Modiste (Bangladesh) Ltd. (Extension)

18 October 2023

Building Information

Lift cores in analysis file

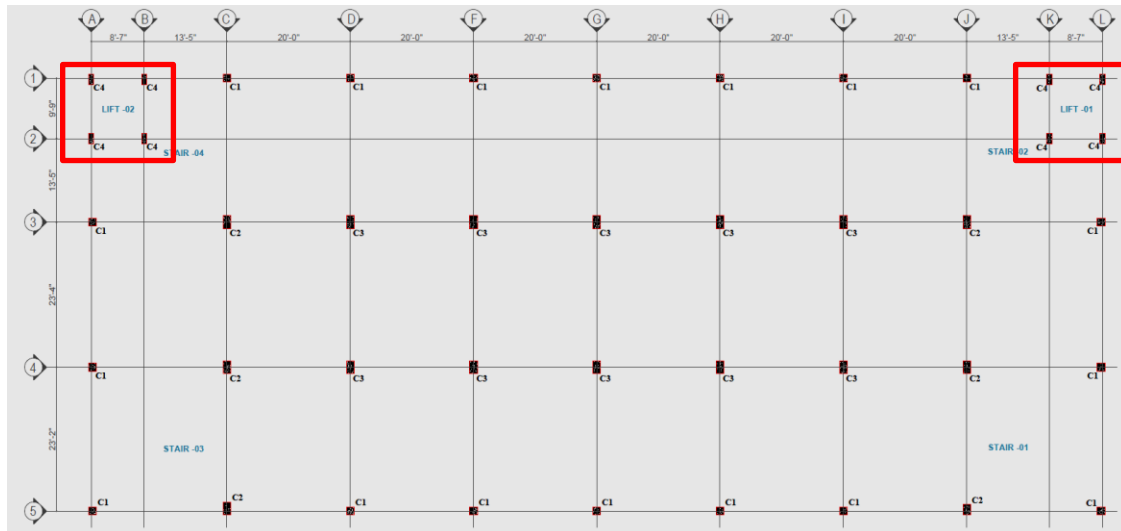
Design documents with software (FEA) analysis file was available on site for building-A. In FEA lift core was considered up to the roof level. But in drawings lift core was shown up to the plinth level. Also lift core was not found above the plinth level on site. Building engineer is required to confirm the lift core presence above plinth level and update the FEA model, check the stability system, design report and other requirements as per BNBC.

Mismatches in as built drawings

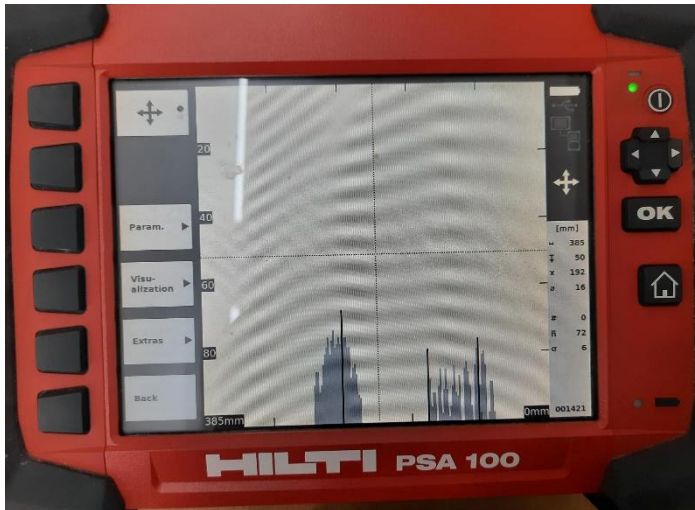
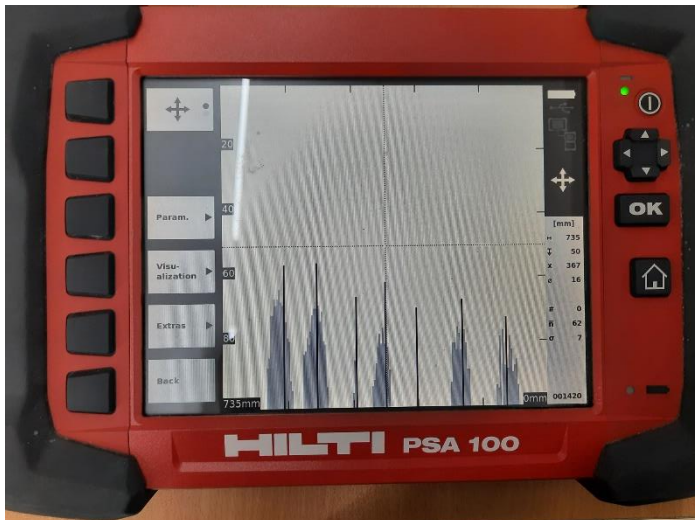
Rebar at C-2 type column not matched with drawings. Four rebars were found at short face and seven rebars were found at long face instead of five and eight, respectively. Total eighteen rebars were found instead of twenty-two rebars. Building engineer is required to confirm the amount of rebar in column and update the drawing.

Dampness at ceiling of 1st and 2nd floor

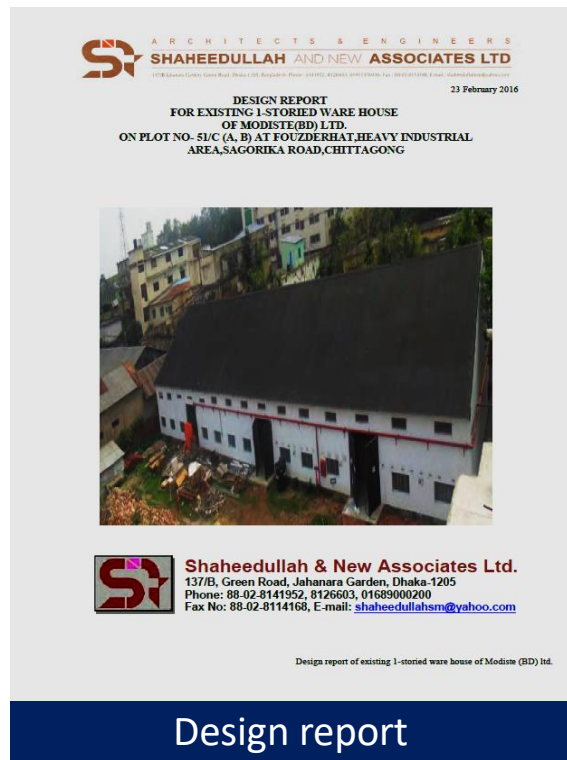
Dampness on ceiling of 1st and 2nd floor was observed. Building engineer is required to seal the source of water and repair the damp areas with suitable methods.

Design report

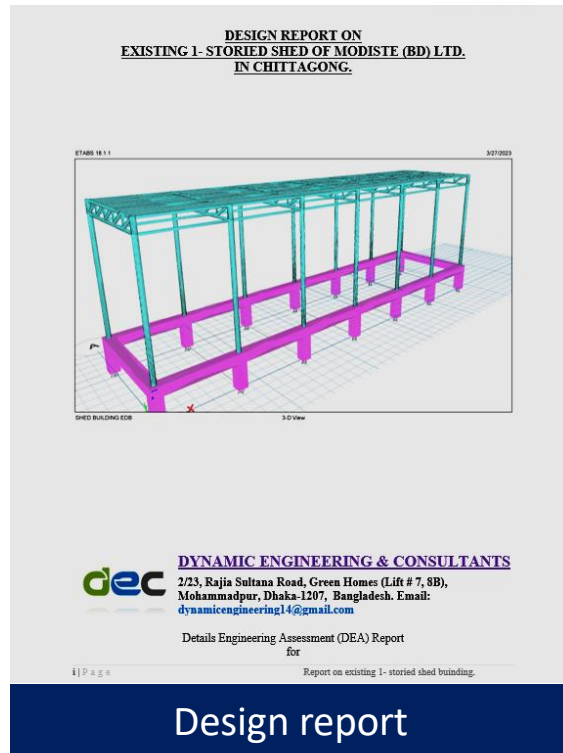
A Design Report was available for the store shed which was prepared based on software analysis. Adequacy of connections and serviceability checks as per BNBC were not incorporated in the design report.

The building engineer is required to incorporate adequacy check of connections and serviceability check in the design report and submit to the RSC for review.
